# Technical Bulletin 262

## Panther Firmware Update V1.47

This technical bulletin provides awareness of a firmware update relating to Panther and Panther PRO.

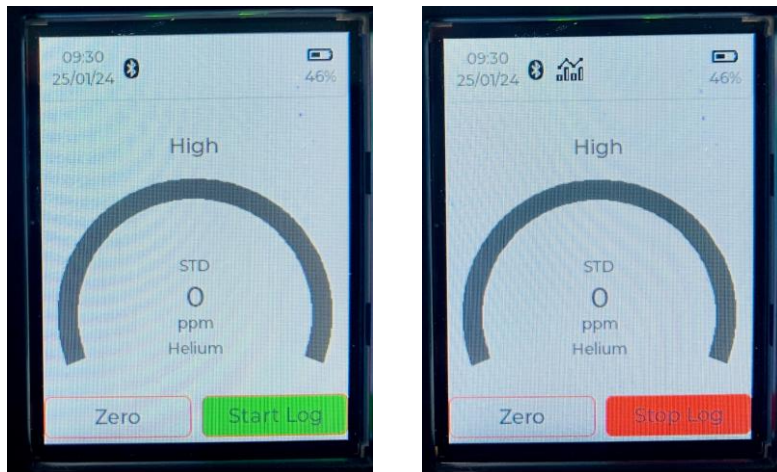
- Colour has been added to the Panther PRO main screen Start/Stop Log buttons to make it clearer when the instrument is datalogging (see images below).
